Permit Application Review

Permit No. 2018-48
Received complete: November 13, 2018

Applicant: Blaine Waters: Villas of Glen Lake, LLC.
Consultant: Todd McLouth; Loucks
Project: Villas of Glen Lake
Location: 5517-5525 Eden Prairie Road: Minnetonka
Rule(s): 4,5,11,12
Reviewer: BCO

EROSION CONTROL PLAN

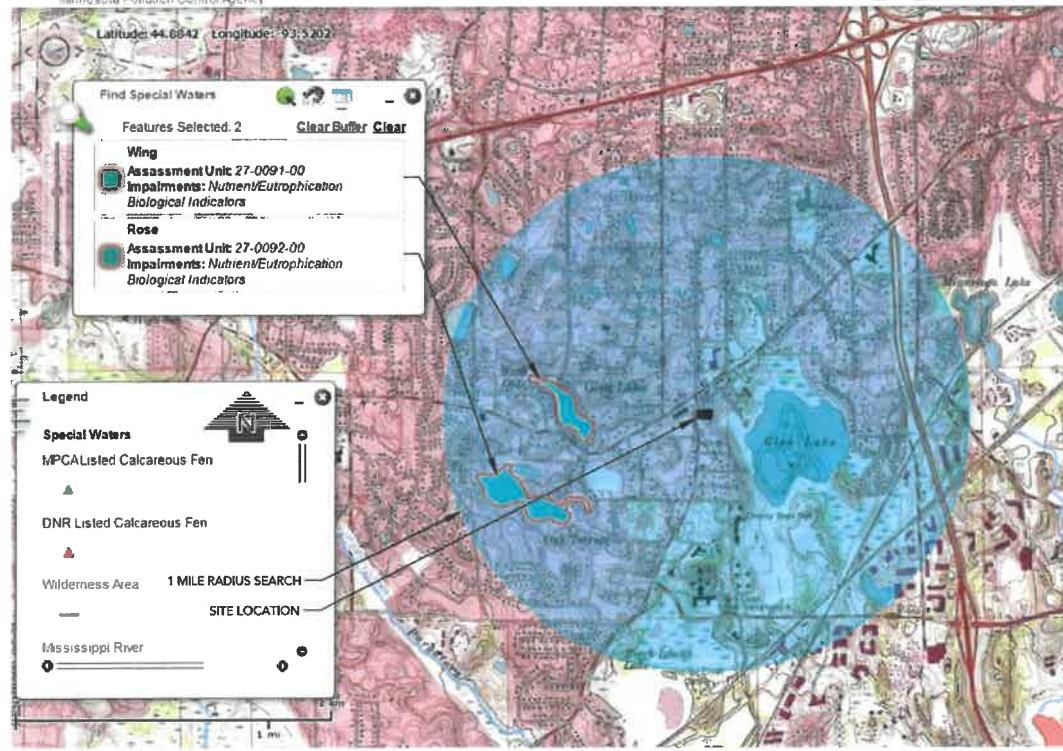
Silt fence is to be constructed at the limits of construction and a rock construction entrance will be provided for erosion control.

The submitted erosion and sediment control plan includes silt fence at the limits of construction and a gravel construction entrance. The project contact is Todd McLouth, Loucks.
